SERVICE BULLETIN

REFERENCE BRAKES

MODEL SW2#

FRONT BRAKE SQUEAL

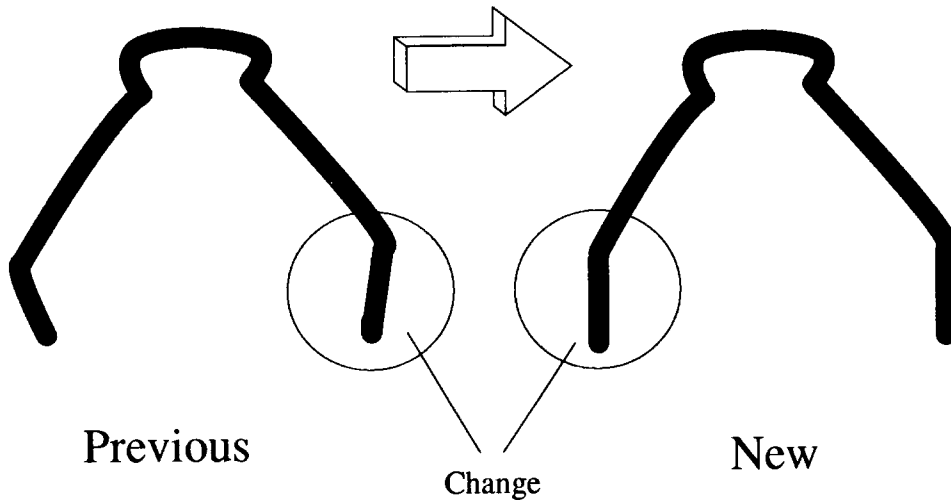
To help reduce front brake squealing noise, the shape of the anti-squeal spring has been changed as follows.

PREV. PART NO.	NEW PART NO.	PART DESCRIPTION
47743-17010	47743-32030	Spring, Anti-Squeal

NOTE: Old and new parts are interchangeable.
